Lakeview Elementary – ESS Relocatable

Bid #: 2024-02C A#04-123480

ADDENDUM 01

June 5, 2024

E-1.2

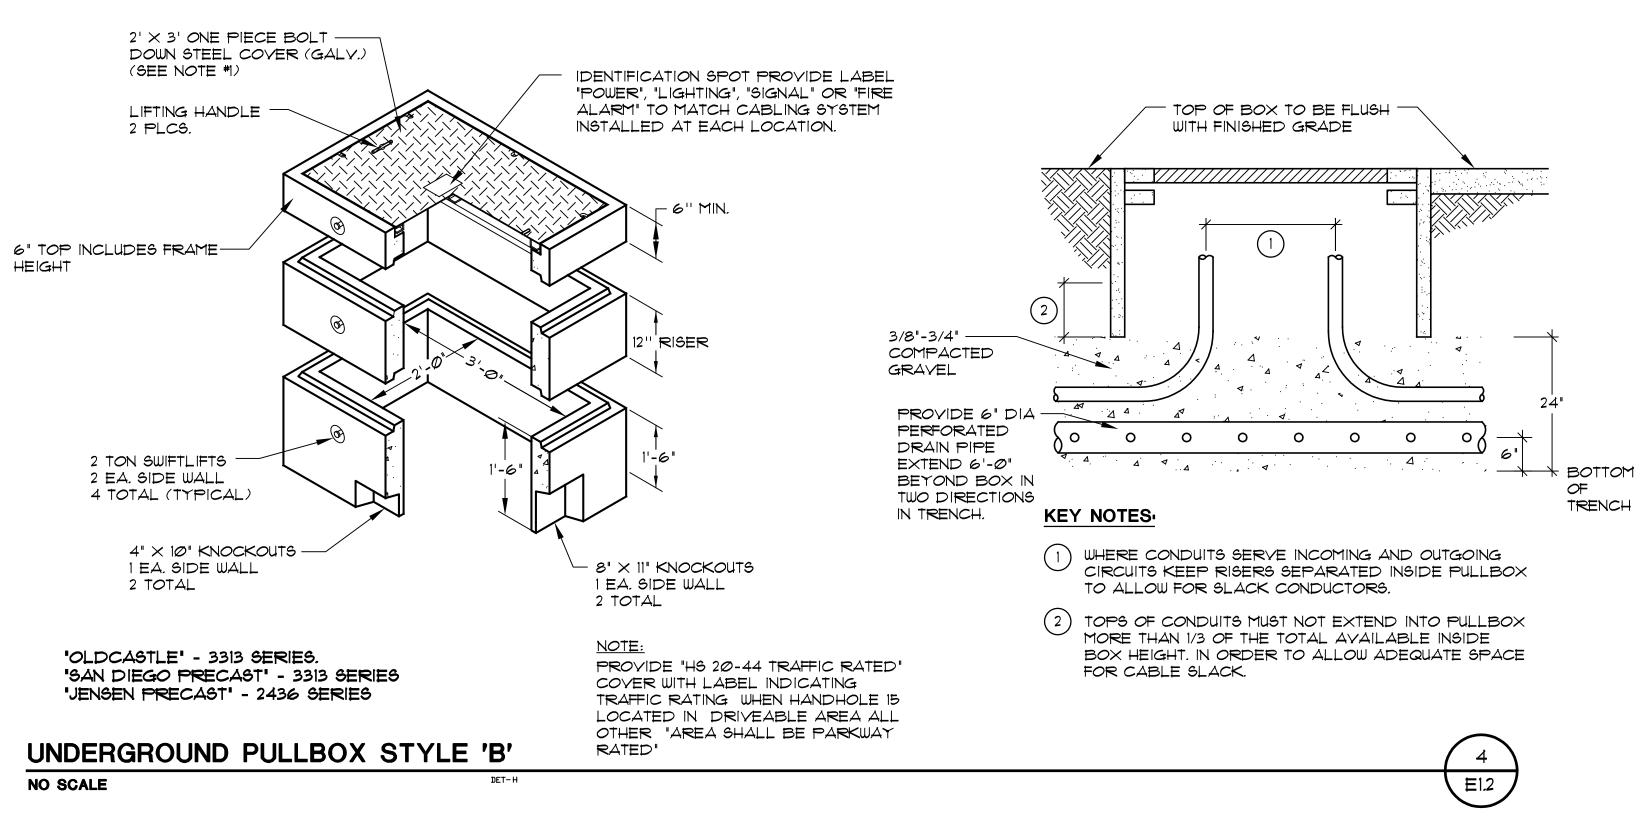
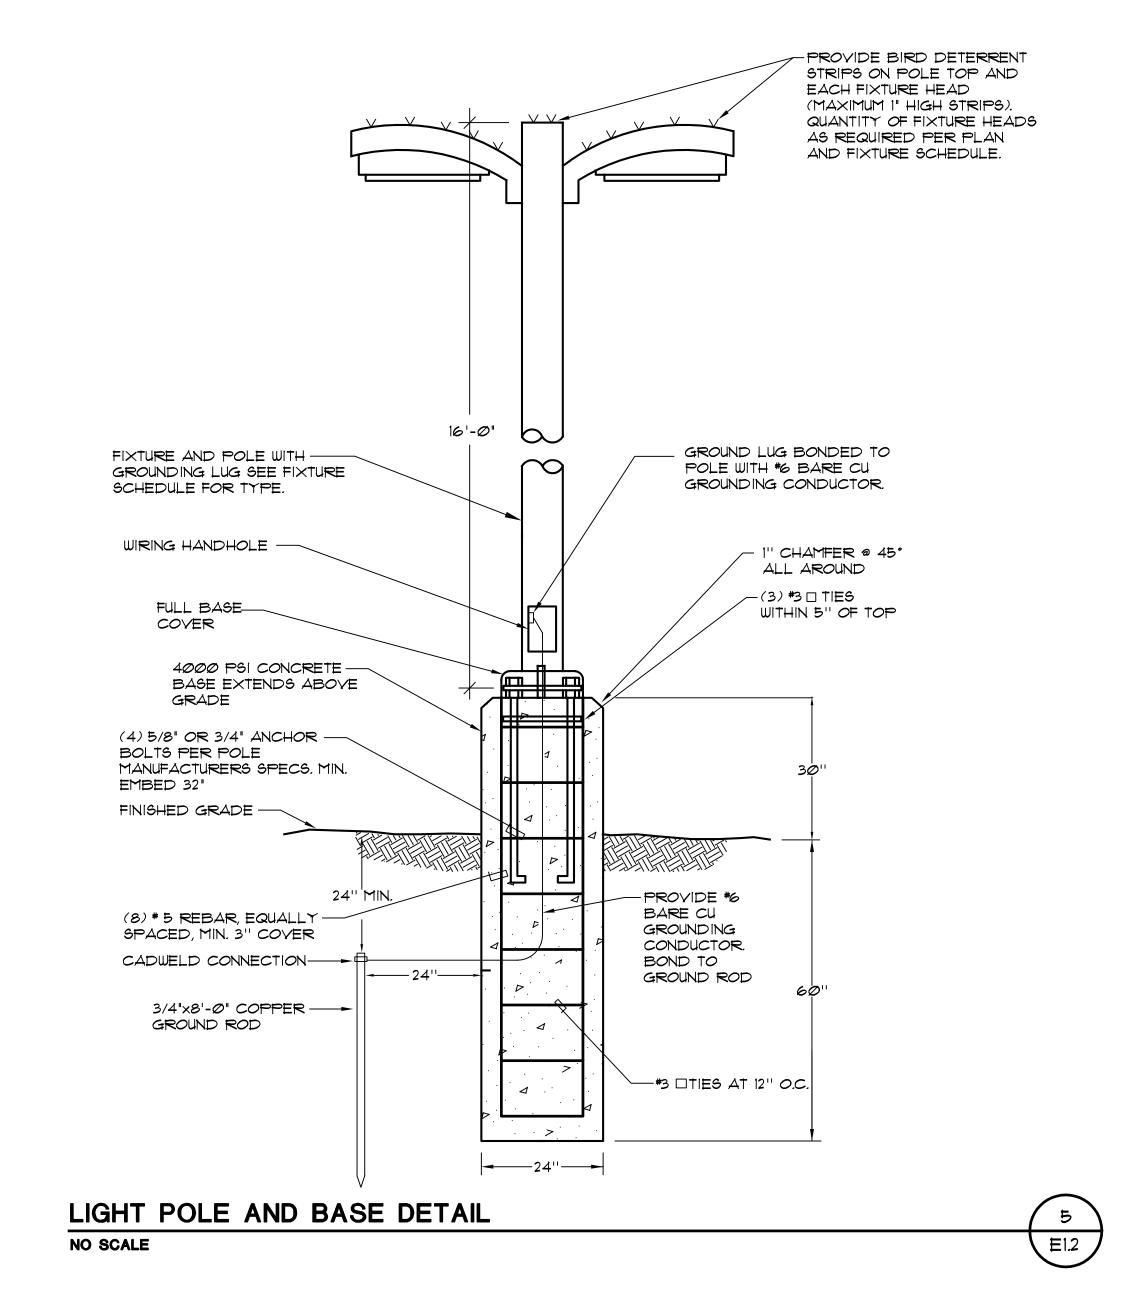
- Item #1. REVISION Electrical Details E-1.2
 - a. Revised grounding detail due to deletion of one panelboard per AMS drawings.
- Item #2. <u>REVISION Floor Plan Power E-3.1</u>
 - a. Revised power distribution due to deletion of one panelboard per AMS drawings.
- Item #3. <u>ADDITION Floor Plan Comm.</u> E-4.1
 - a. Addition of data outlets to match AMS drawings.
- Item #4. <u>ADDITION Communication Details E-4.2</u>
 - a. Added plywood background detail.

2. BOND SEPARATE CONDUCTORS FROM GROUND ROD TO ELECTRICAL PANEL (250-52(5)) AND TO METAL BUILDING FRAME (C.E.C. 250-104(C)). IN ADDITION TO THE DETAIL ABOVE BOND THE ELECTRICAL GROUND TO METAL WATER PIPE IF AVAILABLE. (C.E.C. 250-104(A)).

3. ALL MODULES OF METAL FRAME BUILDINGS AND RAMP SHALL BE ELECTRICALLY BONDED TOGETHER

- (BOLTING ONLY IS NOT ACCEPTABLE BONDING).
- 4. CHECK RESISTANCE TO GROUND. IF RESISTANCE EXCEEDS 25 OHMS, EXTEND CONDUCTORS, AS REQUIRED TO ADDITIONAL GROUND RODS AS NEEDED, SEPARATED BY AT LEAST 6'-Ø" UNTIL RESISTANCE IS 25 OHM OR LESS (CEC 250.53(A)(2)(3)).
